## **ADDENDUM NO. 2**

**Date: September 17, 2007**

**Landfill Construction  
Class I Phase III Landfill – MSW Cell 1 and Ash Monofill Cell 1  
for the Lake County Landfill Located in Tavares  
BID No.: 07-0005**

**FIGURE 1  
ADDENDUM 2  
LAKE COUNTY PHASE III - CELL 1 LANDFILL**

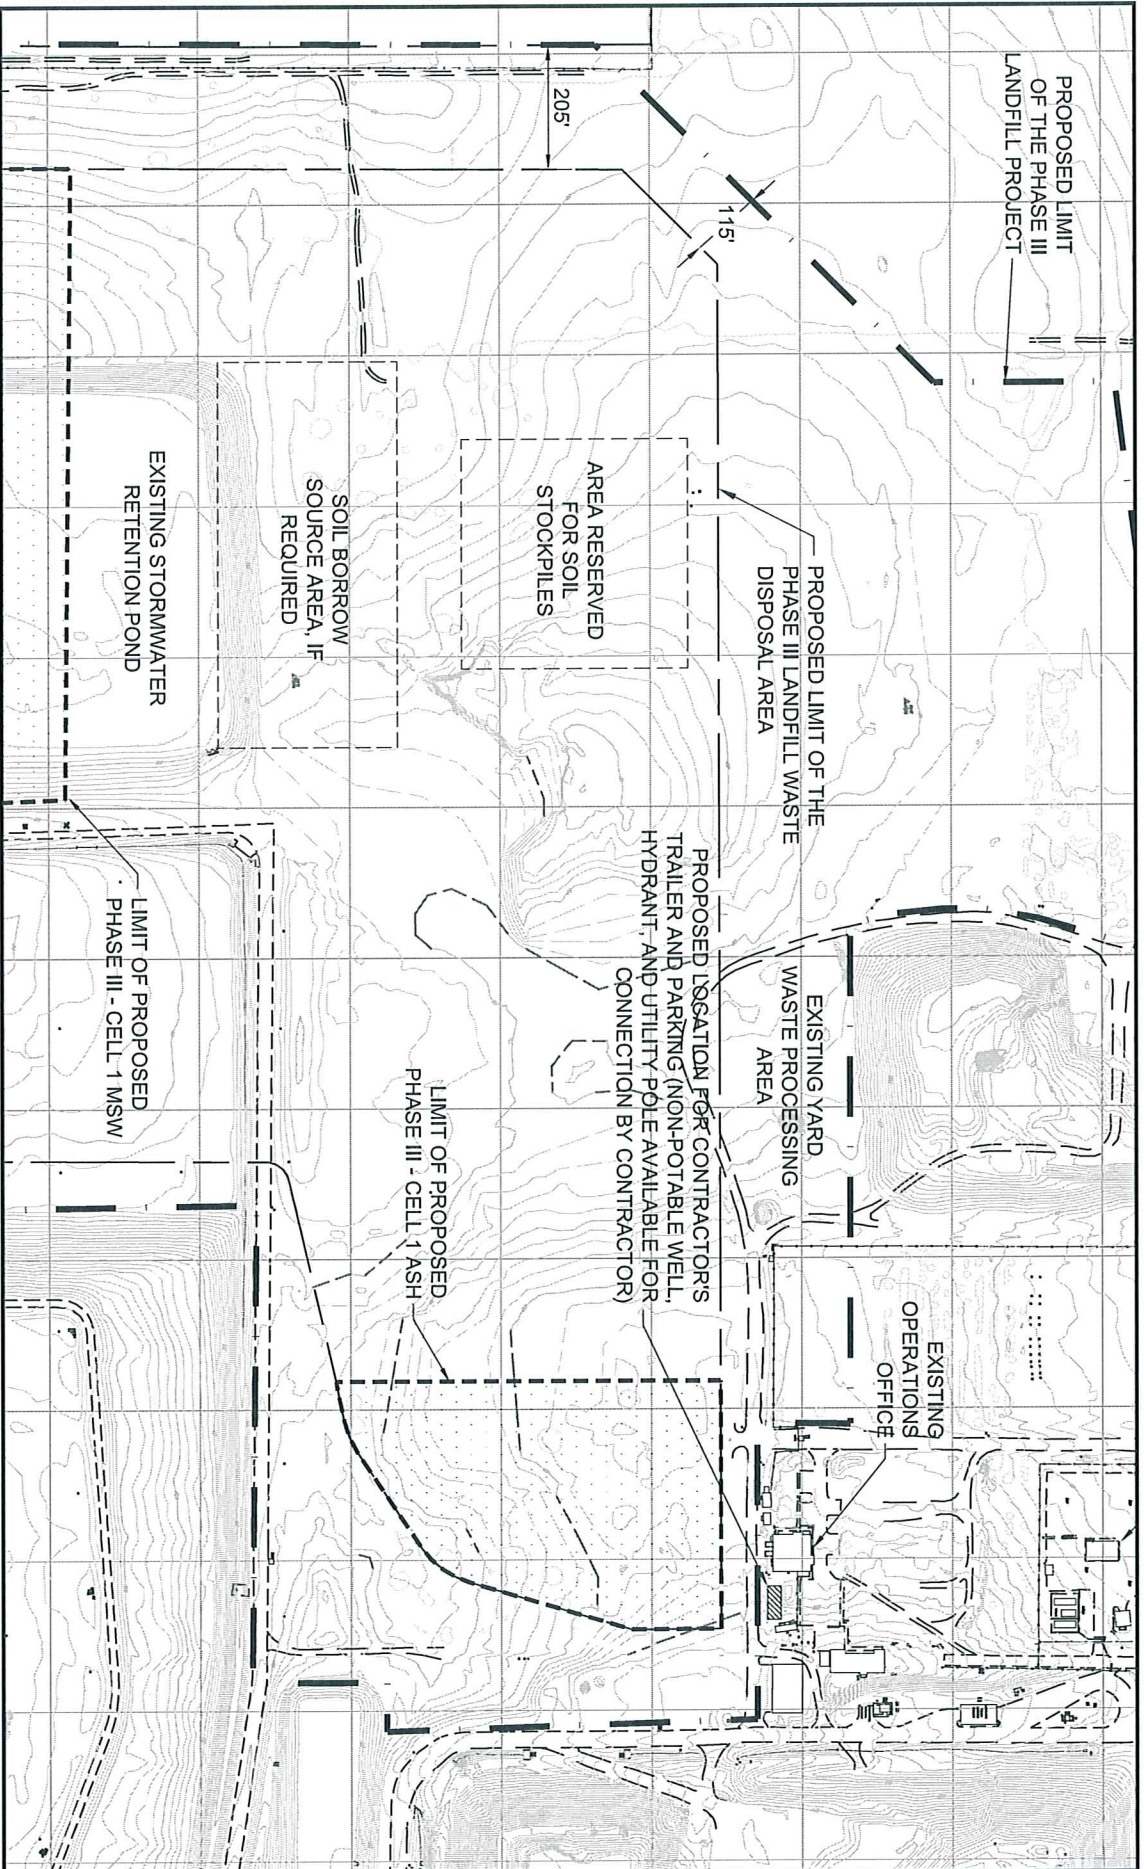
10. In the event that there is a shortfall of soil material during construction (excavation, grading, and the drainage/protection layer), the Contractor will be allowed to use on-site soils to the north of the existing stormwater retention pond north of the proposed MSW Cell (see Figure 1). The Contractor will need to prepare a borrow source excavation plan for approval by the Owner and/or Engineer prior to using soils from this area.

11. The location for the Contractor's trailer is shown on the site plan included with this addendum (Figure 1). It is intended that the Contractor provide a work space (field office) in the construction trailer for the Construction Manager/CQA Consultant/Engineer. The area required for the field office is described in Specification Section 01590. The conference area specified can be a common area for both the Contractor and the CQA personnel.

14. Soils excavated from the site can be stockpiled on-site in the general area designated on the site plan included with this addendum (Figure 1) until they are used in the project. However, siltation controls specific to the stockpiles, such as silt fencing or hay bales around the base, shall be utilized to prevent erosion into existing stormwater swales and ponds.

**FIGURE 2  
ADDENDUM 2  
LAKE COUNTY PHASE III - CELL 1 LANDFILL**

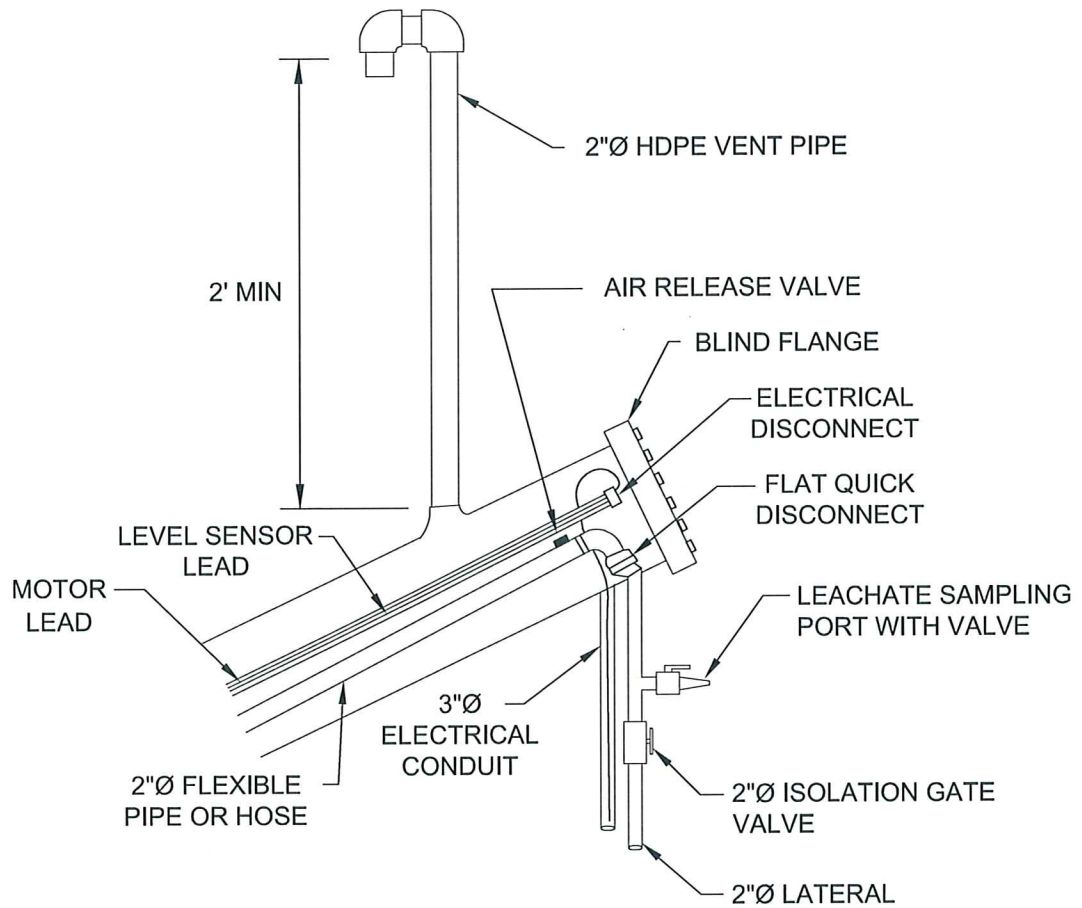
21. It is the Contractor's responsibility to dispose of land clearing debris. Open burning will not be allowed on-site.
22. The Contractor is responsible for the installation of pedestal, drainage pipes, and anchor bolts for only the one proposed leachate storage tank. No pedestal, drainage pipes or anchor bolts are required for the future tank as part of this project.
23. Although not shown on the plans, 2-inch isolation (gate) valves shall be installed on

the outlet of each pump riser discharge line to prevent the possibility of backflow if the pump in question needs to be removed for maintenance. The valves are specified in Section 15101 of the Specifications. A total of ten (10) such valves are required, five (5) on the primary leachate riser lines and five (5) on the secondary leachate riser lines. The locations of these valves on each pump riser discharge line are shown on the attached drawing (Figure 2).

1. THIS DETAIL REPLACES THE REFERENCED DETAIL ON SHEET 000-C-004 OF THE DESIGN DRAWINGS.
2. THE GATE VALVE IS FURTHER DESCRIBED IN SPECIFICATION SECTION 15101.
